## JOINT REGIONAL PLANNING PANEL (Sydney East Region)

<b>JRPP No:</b>	<b>2015SYE156</b>
<b>DA No:</b>	<b>DA15/1325</b>
<b>Local Government Area:</b>	<b>Sutherland Shire</b>
<b>Proposed Development:</b>	<b>Construction of mixed use development including 116 residential apartments with a ground floor commercial tenancy and basement car parking</b>
<b>Street Address:</b>	<b>1085, 1081 &amp; 1091A Old Princes Highway, Engadine</b>
<b>Applicant/Owner:</b>	<b>Regent Pacific Capital</b>
<b>Number of Submissions:</b>	<b>Eight</b>
<b>Regional Development Criteria (Schedule 4A of the Act)</b>	<b>General Development over \$20 million</b>
<b>List of All Relevant s79C(1)(a) Matters</b>	<ul style="list-style-type: none"> <li>• <b>State Environmental Planning Policy No. 65 – Design Quality of Residential Flat Development</b></li> <li>• <b>Apartment Design Guide</b></li> <li>• <b>State Environmental Planning Policy (Building Sustainability Index: BASIX) 2004</b></li> <li>• <b>Greater Metropolitan Regional Environmental Plan No. 2 – Georges River Catchment</b></li> <li>• <b>Sutherland Shire Local Environmental Plan 2015</b></li> <li>• <b>Draft Sutherland Shire Development Control Plan 2015</b></li

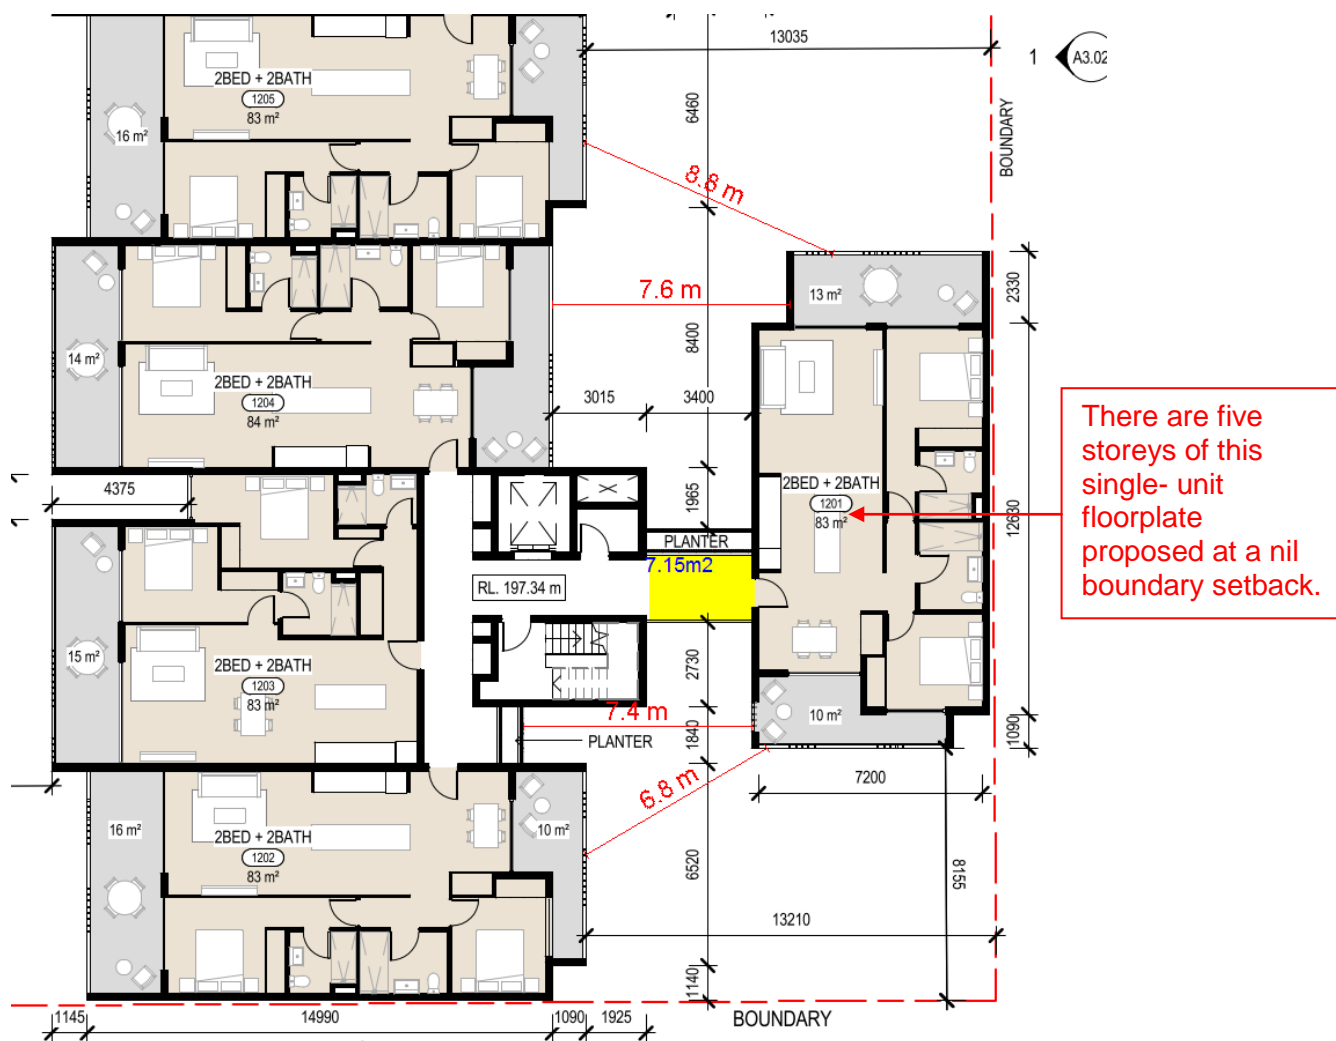
The bulky rear buildings have nil side setbacks and the awkward shape of the site will mean that blank walls are presented to the rear and side boundaries of neighbouring properties. High, featureless walls will be seen 'in the round' from public reserves and streets within the Engadine Centre and from nearby low density residential land. Nil setbacks are acceptable at the street in an urban centre

setting, where another building is likely to 'couple' with the development. However, in a mid-block or facing onto another zone (as in this case) they are not sustainable.

The fact that there are sites zoned 'Infrastructure' to the south of the site does nothing to diminish this. The site itself was until ten months ago zoned in the same way – it cannot be argued that sites zoned Infrastructure are incapable of residential redevelopment. A scheme that is FSR compliant is less likely to need to 'build to the boundary' and would also go some way to resolving Council's access, landscaping and amenity concerns. Setbacks should be informed by the ADG.

Figure 4: relationship between building 2 and building 3 (level 5).

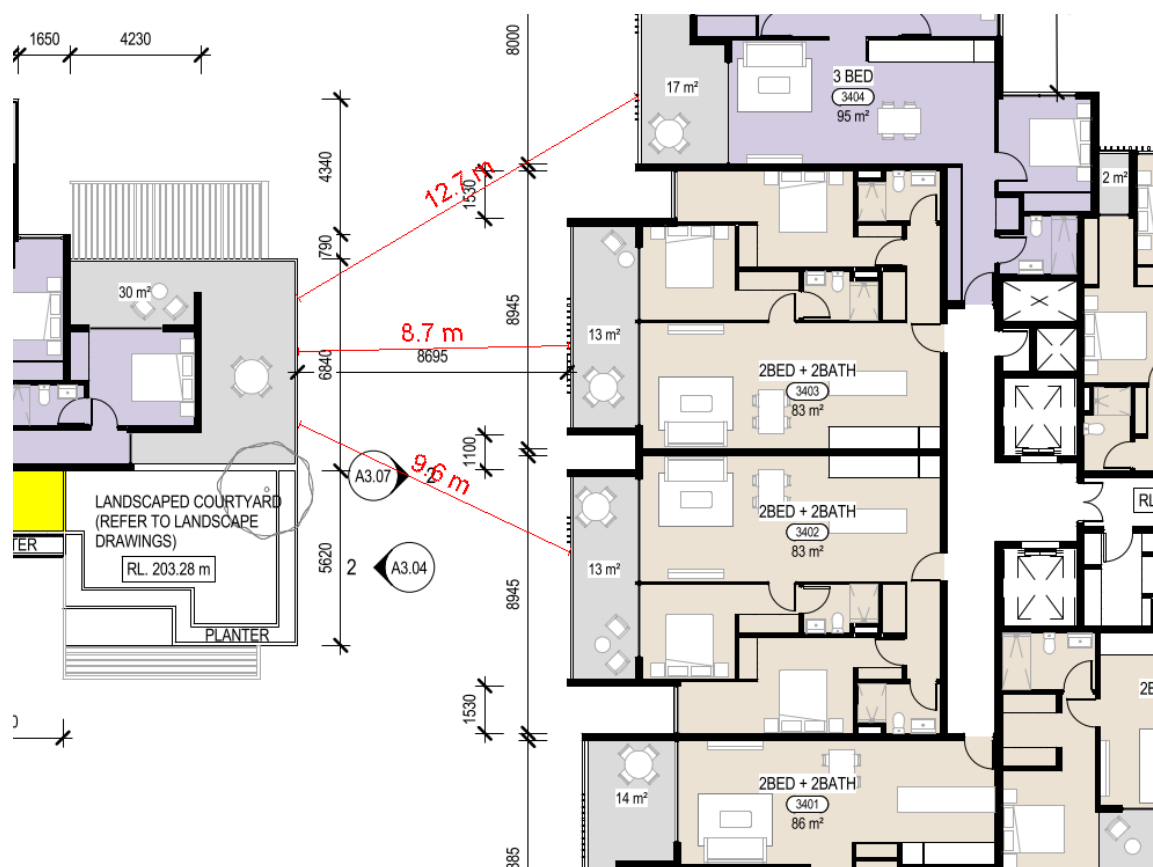
The building separation between building 2 to the other two buildings on site also falls short of the ADG recommendations. As with building 1, the proposal seeks to overcome the separation distance deficiencies by incorporating defensive design measures such as deleting (or providing hoods) to bathroom windows, providing bedroom windows at balcony under croft areas, and by providing solid walls to balcony edges. These design measures have obvious solar access and ventilation implications for the affected units, and also create unarticulated facades.

The privacy implications are most apparent between the central and front towers, at the fifth level. Here the ADG calls for an 18m separation. The proposal provides less than half (9.3m deficient) of this requirement.

Figure 5: relationship within building 3- second level.

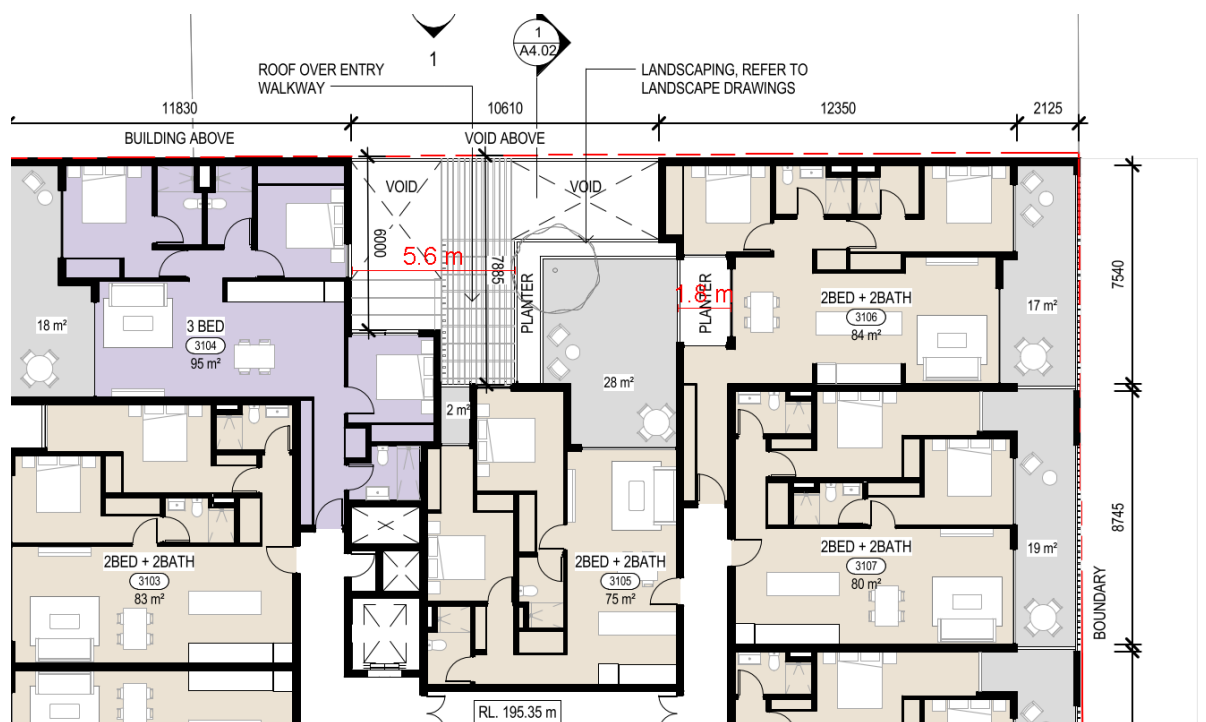
As illustrated by figure 5 below, the separation shortfalls of the building 3 design are most obvious on the second level, where the dining room servicing unit 3106 is separated from the balcony of unit 3105 by a 1.8m planter box, and separated from the bedroom of unit 3104 by a distance of 5.6m.

This is 10.2m-6.4m deviation from the 12m recommended by the ADG to achieve a reasonable level of visual privacy.

Above the second level, the separation remains deficient of the ADG recommendations, providing a separation 2.8m-7.1m between the apartment balconies.
